SEWAGE DISPOSAL SYSTEM

MARYLAND STATE DEPARTMENT OF HEALTH

INDEXED
04-329110

SUBDIVISION _____ ROAD 2821 Duval Rd LOT _____

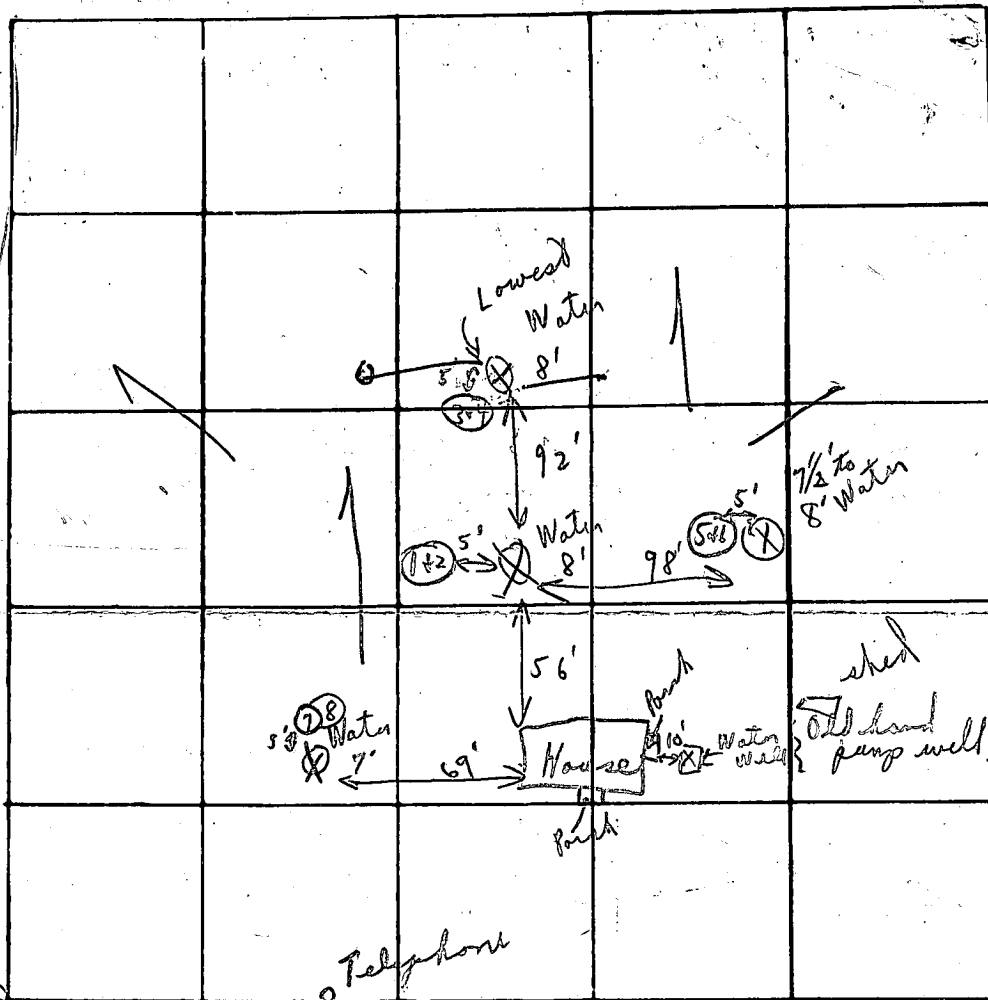
6/9/78 REASONS FOR REJECTION OR HOLDING 6/9/78 Mr. Sick Digger 6/9/78 Water below

clay - insufficient area for future repair and
to be able to install an acceptable system
for present.
6/29/78 Retested shallow C.B. Note shallow water well

DATE	TEST NO.	DEPTH	PRE-WET		TEST - 1" DROP		TIME
			START	STOP	START	STOP	
6/27/78	1	And 11.52 3'	1:27	1:29	1:29	1:33	4m
	2	5'6"	1:25	1:44	1:44	2:08	24m
	3	3'	1:37	1:38	1:38	1:40	2m
	4	6'	1:35	1:38	1:38	1:44	6m
	5	3'	1:48	2:16	2:16	2:18	3:05 1/8"
	6	6'	1:45	1:50	1:50	2:07	17m
	7	3'	1:58	2:23	2:23	2:39	3/4" 3rd most
	8	6'	2:00	2:02	2:02	2:11	9m
		8' Water 6/27/78					
		(6/27/78) Need 15,000 reserved - soil spotty

6/12/78 approved only for sealed Tank with approved alarm device. Copy of contract with scavenger to show pumping + cleaning schedule of tank.
DWM

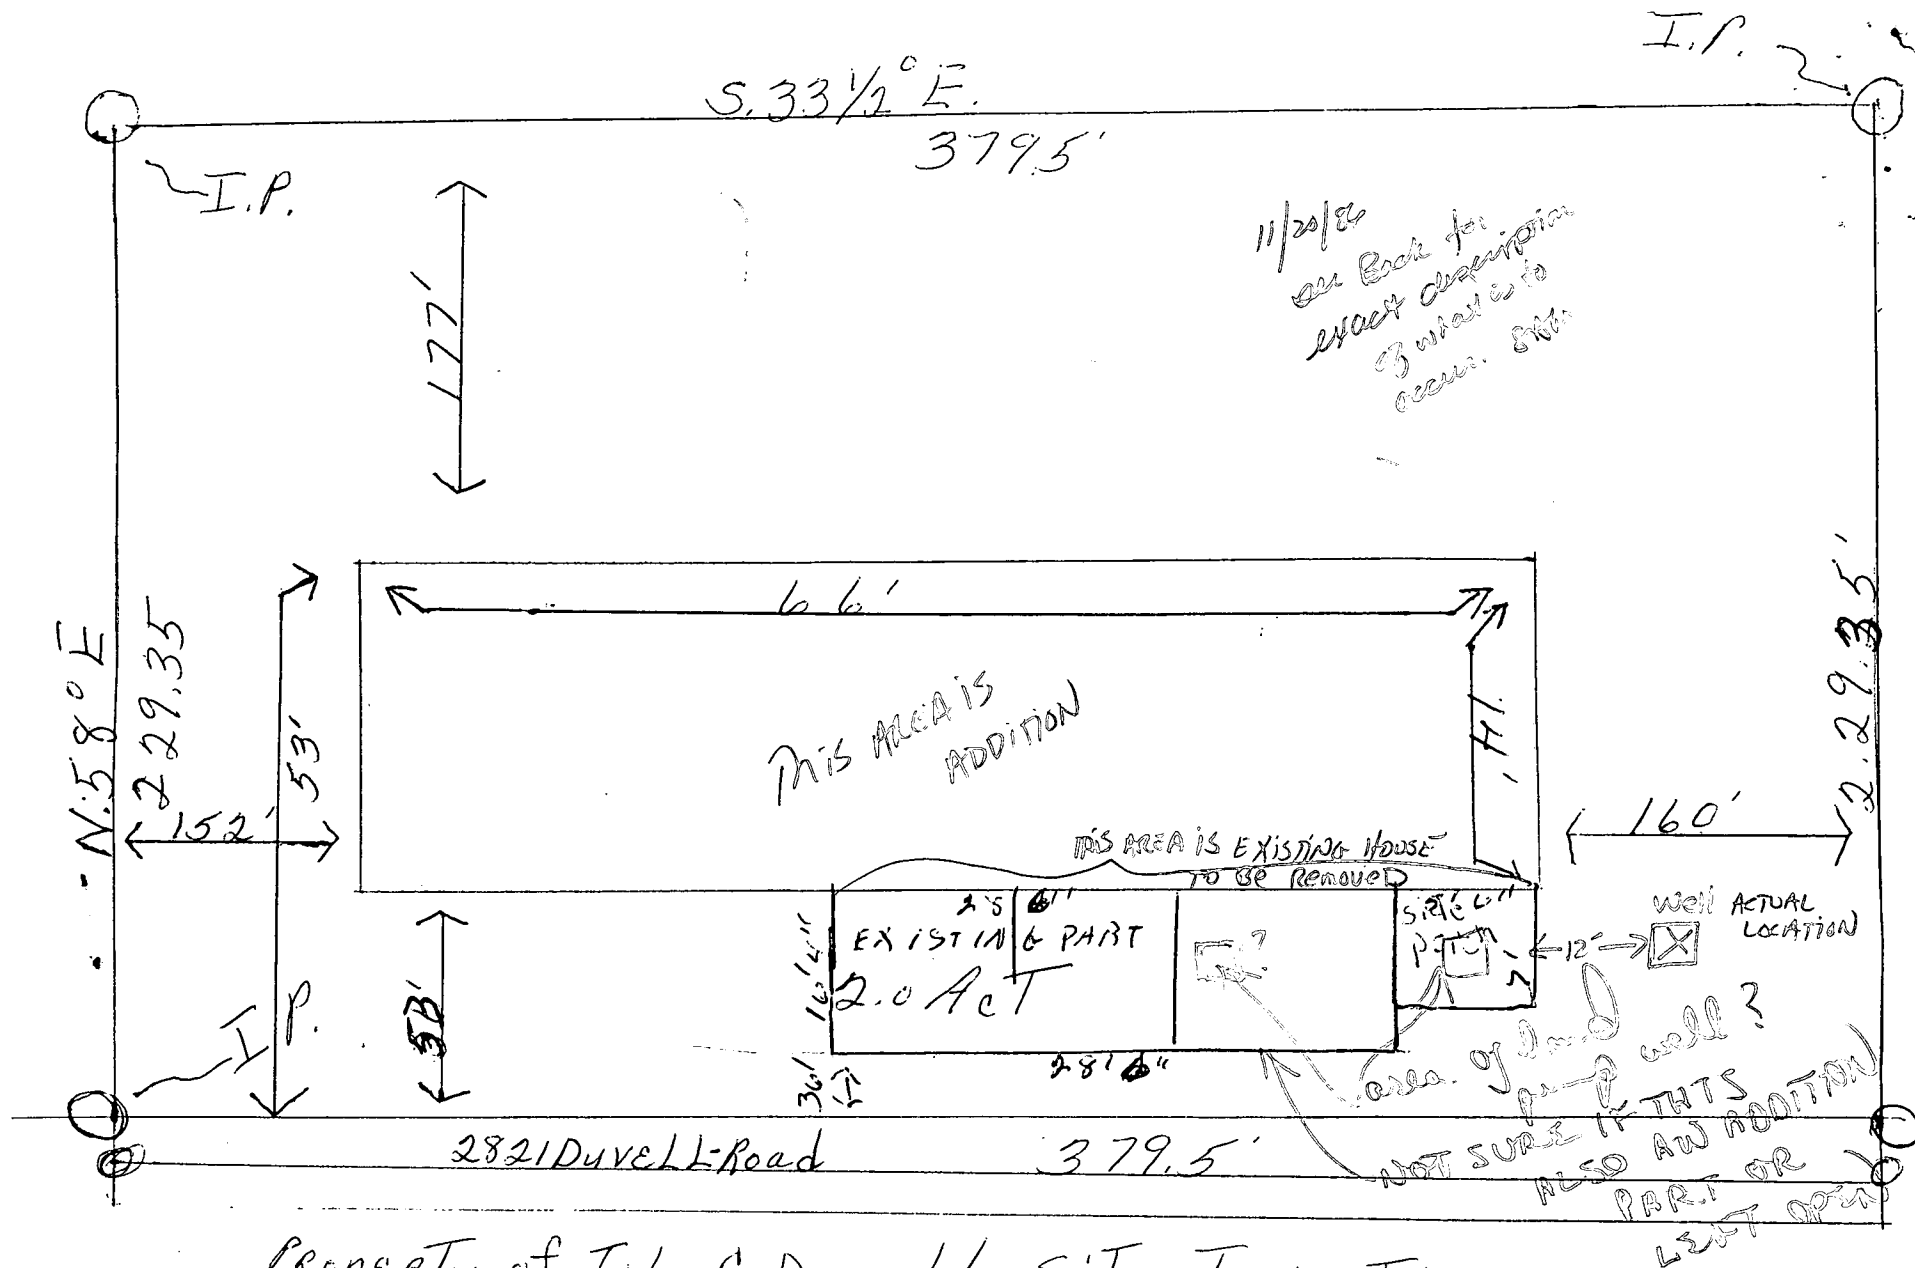
Please be advised that the Howard County Health Department, Bureau of Environmental Health, cannot recommend approval for the above referenced building permit application at this time. This office is unable to determine if adequate septic capacity exists to support the requirements of the new addition.

Additional information on total square footage of new home addition and/or total number of bedrooms is needed. If the information is for a large addition and/or an increase in the number of bedrooms, a repair percolation test would be required to determine if sufficient septic repair area may be needed. The application may be obtained from this office and the test fee is \$25.00 (Check payable to Director of Finance).

WITH THIS PLANNED ADDITION,

INCLUDES ALSO THREE BED-
ROOMS TOTAL, *for info*

RECOMMENDED FOR APPROVAL
NO INCREASE IN FLOW IS IMPLIED
WITH THIS PLAN.
